**MEMORANDUM – MANDATORY REFERRAL**

**SUBJECT:** 1. Forest Conservation Plan: Silver Spring Transit Center, Colesville Road and Wayne Avenue, CBD-2 Zone, Silver Spring Central Business District Sector Plan  
Colesville Road and Wayne Avenue, CBD-2 Zone, Silver Spring Central Business District Sector Plan

2. Mandatory Referral No. 04106-DPW&T-1: Silver Spring Transit Center Phase 2, Colesville Road and Wayne Avenue, CBD-2 Zone, Silver Spring Central Business District Plan

Exhibit 4 – Level One Plan

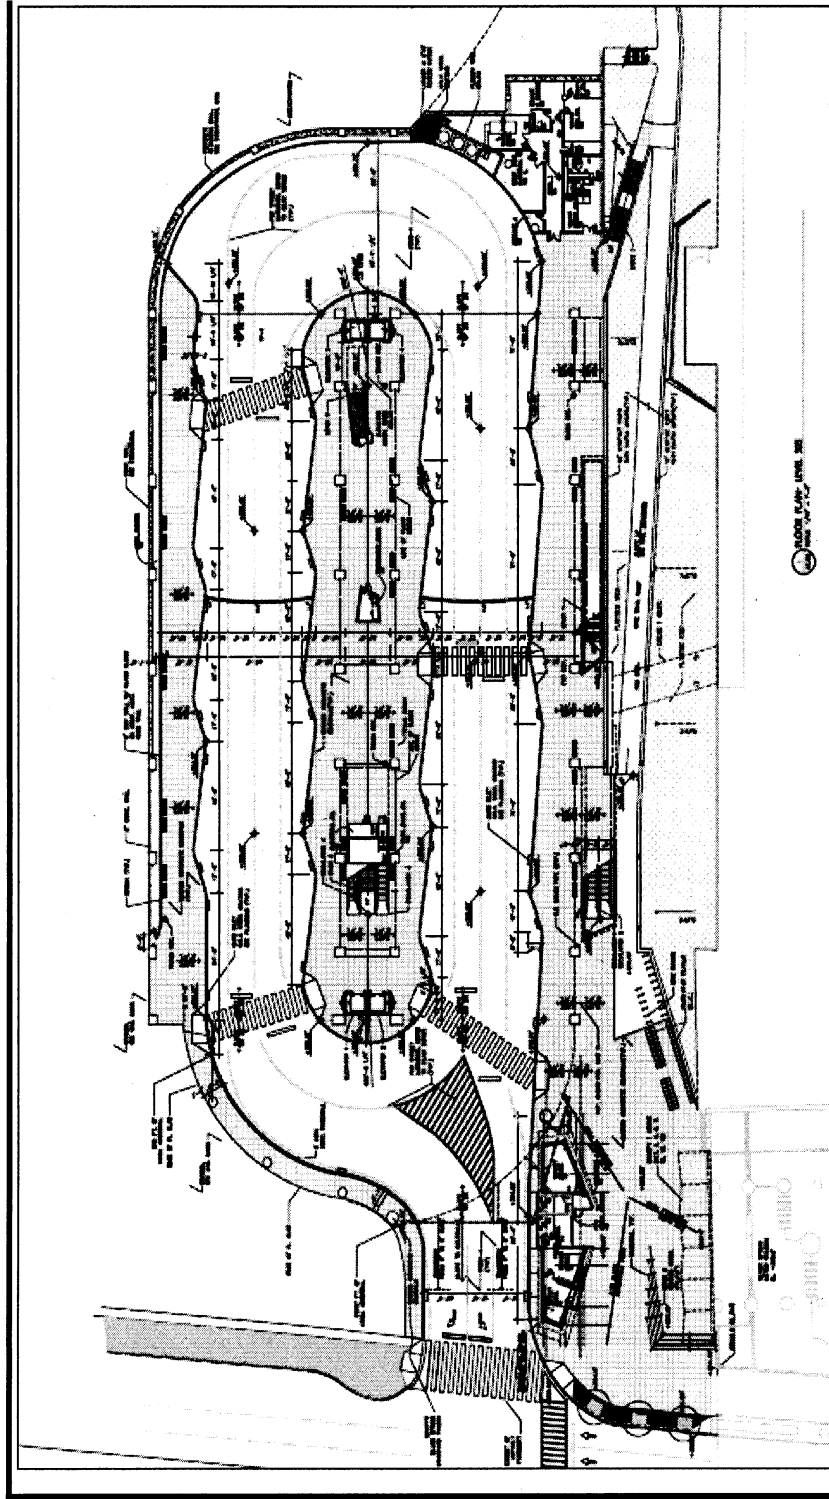
9. Consider another approach to the pavement marking proposed on the Lower Level entrance at Colesville Road for guiding buses to and from the two different circulation patterns. The large crosshatch area as currently proposed appears to cover an area that buses cannot avoid.

Exhibit 8 – Metro Plaza Park Concept Plan

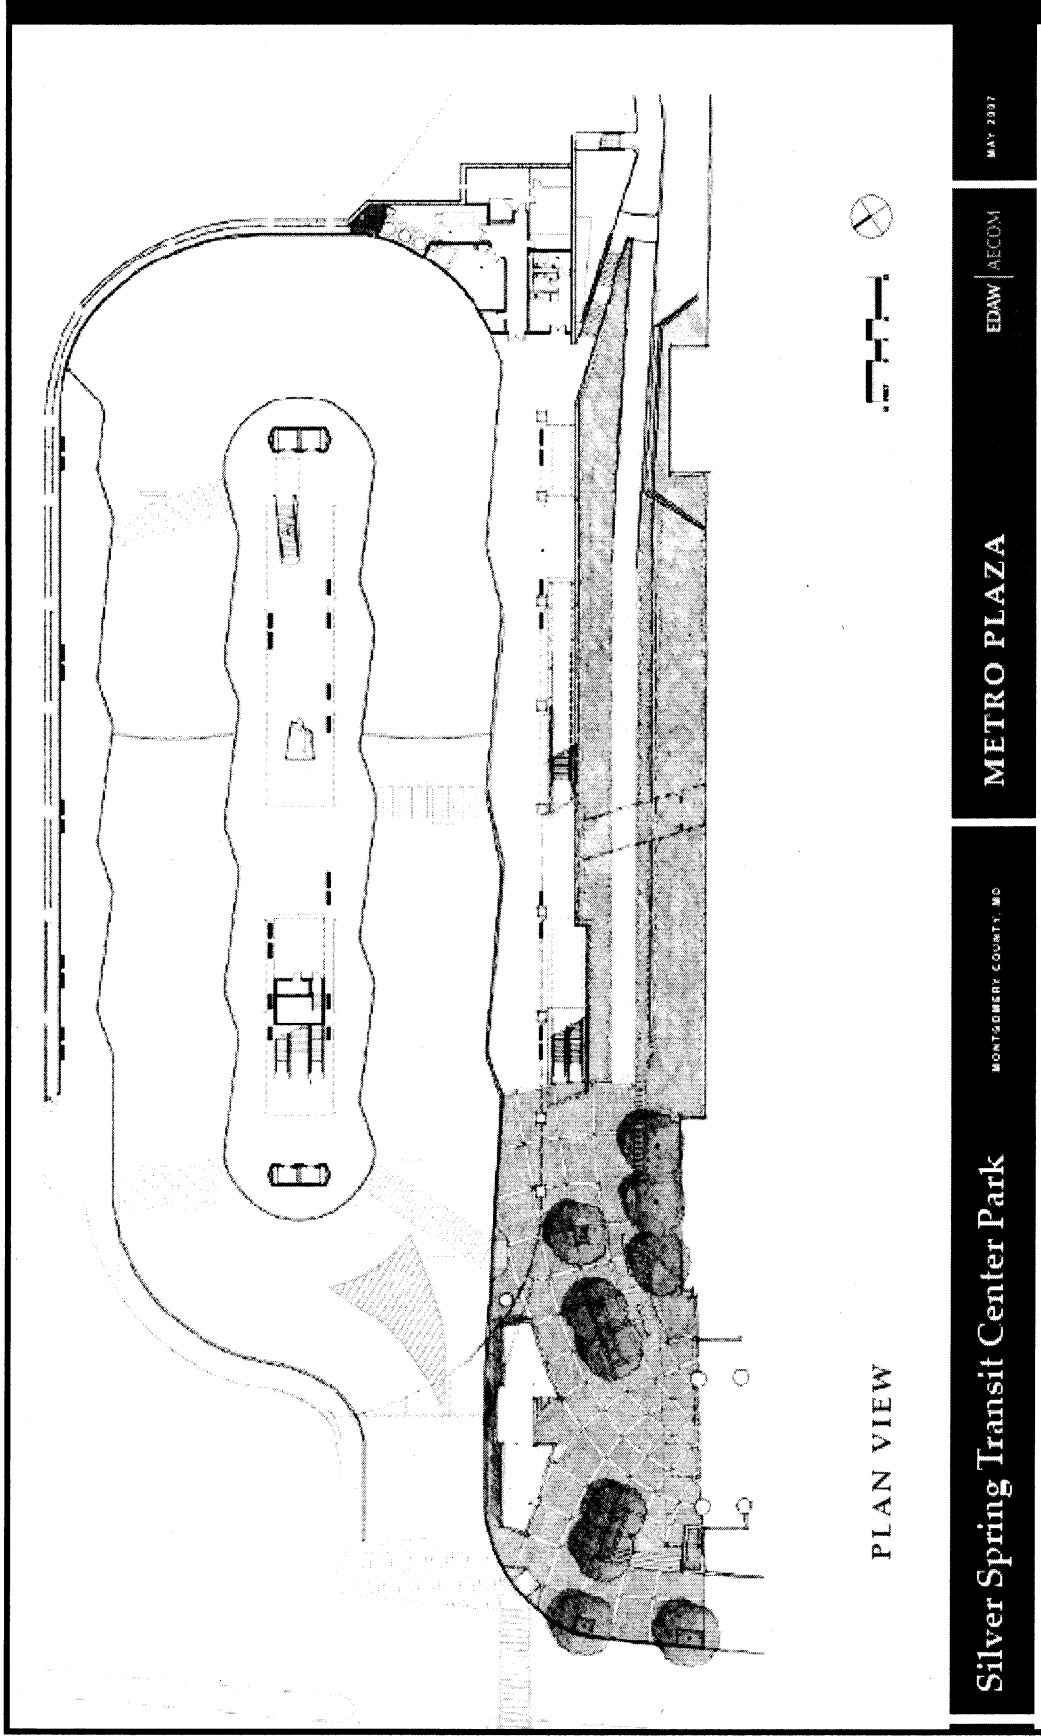
- i. The plan for Park #2 shall be further developed to ensure that the proposed park area is significantly enhanced to justify the reduction in overall replacement parkland. The plan may include public art, a water feature, drinking fountains, a high quality paving treatment similar to that in Area #1, benches, signage, bike racks, extensive plantings, lighting, etc.

This park is approximately 12,074 square feet in size and will feature a landscaped area of significant quality and dimension so that users of the Transit Center come to know it as a landmark and gateway to Silver Spring. A concept plan is shown in Exhibit 8. Key features of this park include a dozen mature trees, distinct paving defining the plaza area and providing passive directional guidance to and from the Transit Center and Metrorail entrance, as well as other amenities, such as seating and informational signing. It is also the terminus for the MBT.

Exhibit 9 – Jughandle Park Concept

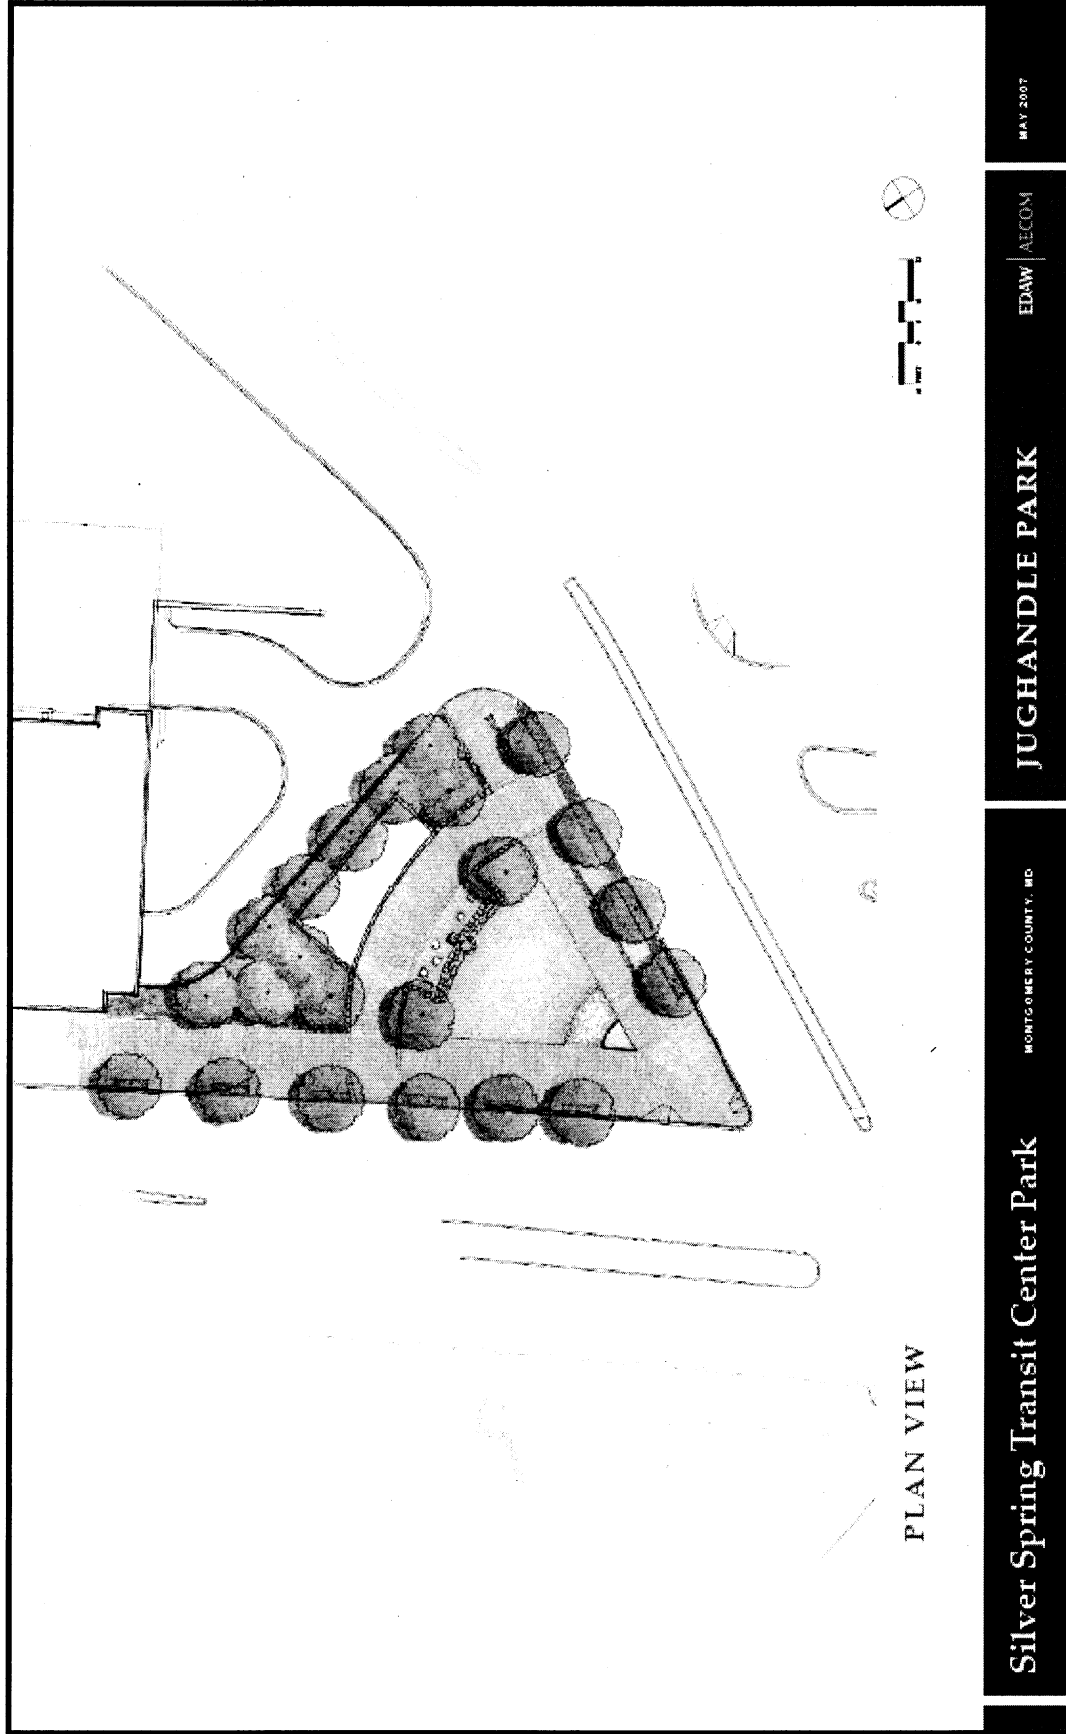
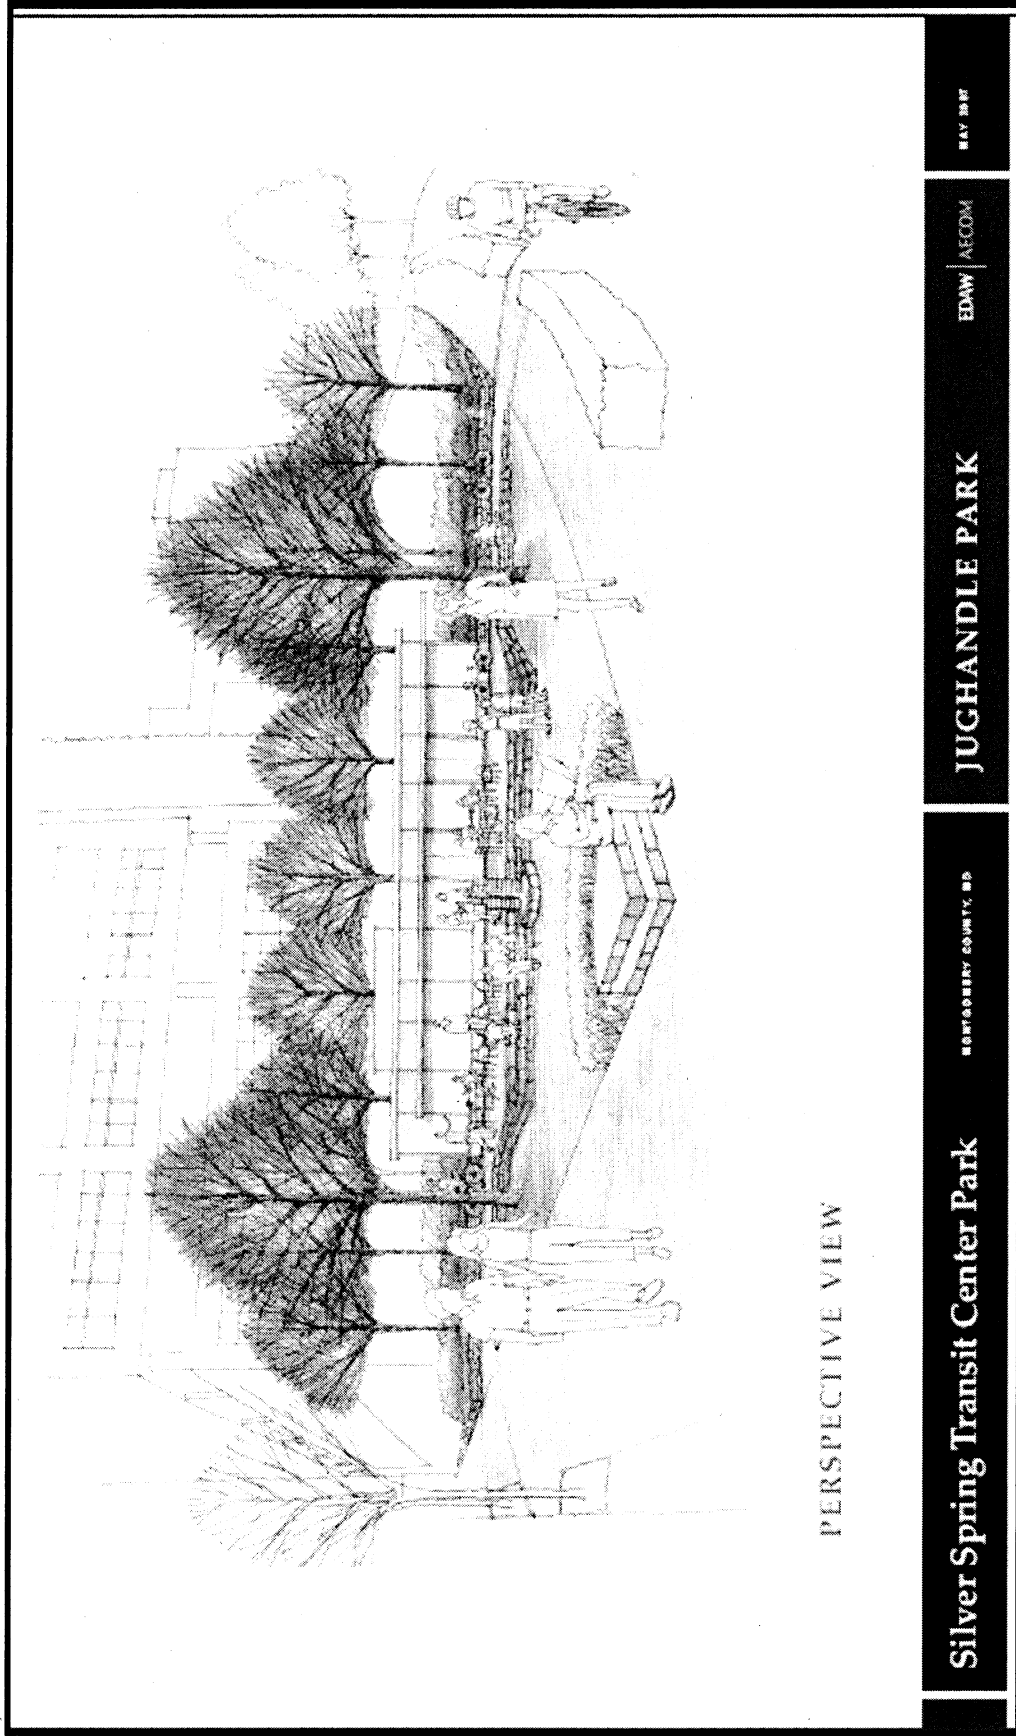
This park is approximately 11,590 square feet in size and will feature trees, water and benches in what will be an area of transition between the Transit Center and Georgia Avenue. A concept plan for this park is provided in Exhibit 9 and a perspective is shown as Exhibit 10. This park has also been identified as the potential location of a future bike station – given the park’s location at the point where the Metropolitan Branch Trail / Capital Crescent / and Silver Spring Green Trail converge (see Exhibit 11). The concept plan has been developed so that it could eventually accommodate a 1,500 square foot footprint of a potential bicycle station.
